Interactive comment on “A multi-purpose, multi-rotor drone system for long range and high-altitude volcanic gas plume measurements” by Bo Galle et al.

Response to questions and suggestions from Reviewer 2

Fig. 1. New Fig.1 showing an example of drone flight log

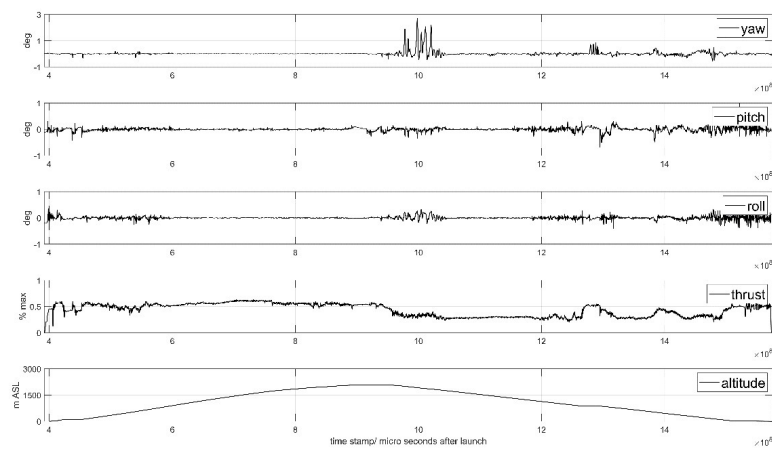
Reviewer: Page 4, line 150: At first glance, the presented finding that a balance of “rise and forward motion” is more favourable in terms of energy consumption than “moving only in one direction at a time” seems to be obvious. But possibly a rule for the optimal balance between “rise and forward motion” in terms of minimum energy consumption has been identified. If applicable, this should be specified.

Response: More details on this are given and are illustrated by a graph showing flight-logs for a typical flight (Fig.1.). “When ascending and moving horizontally, it was found that energy consumption could be reduced if the rise and forward motion was balanced in an optimal way, as compared to moving only in one direction at a time. This is because a considerable horizontal component in the movement gives a lift that reduces the energy consumption for maintaining the vertical position. An additional advantage is that the drone then fly in undisturbed air with less turbulence compared to a clean vertical movement.”

Fig. 2. This is the new Fig.2., replacing the earlier Fig.1.

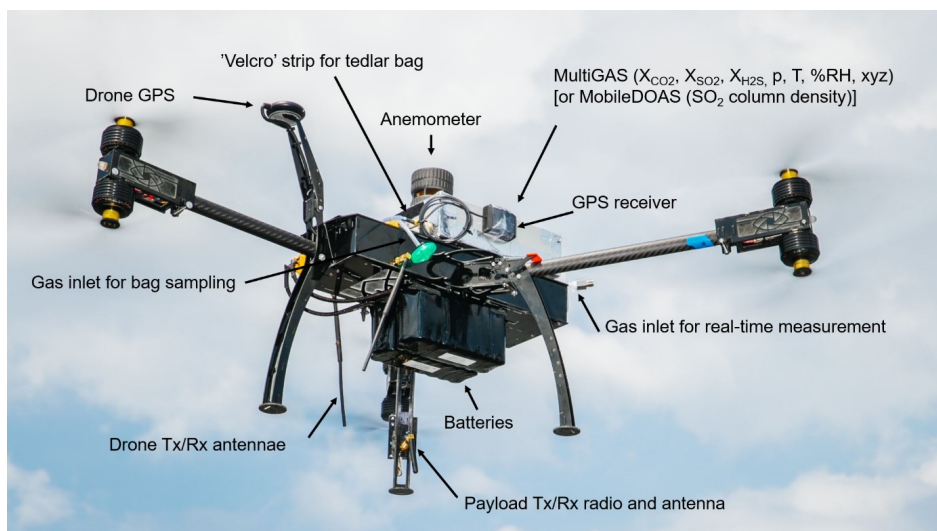
Reviewer: In addition to the photo in Fig. 1, it would be useful to have a sketch showing the exact location of the onboard anemometer and in particular its horizontal and vertical distances from the propellers.

Response: We have not included a specific figure for this but instead improved Fig 1 (now Fig 2) to include the location of the anemometer. This new figure is attached here as Fig.2.
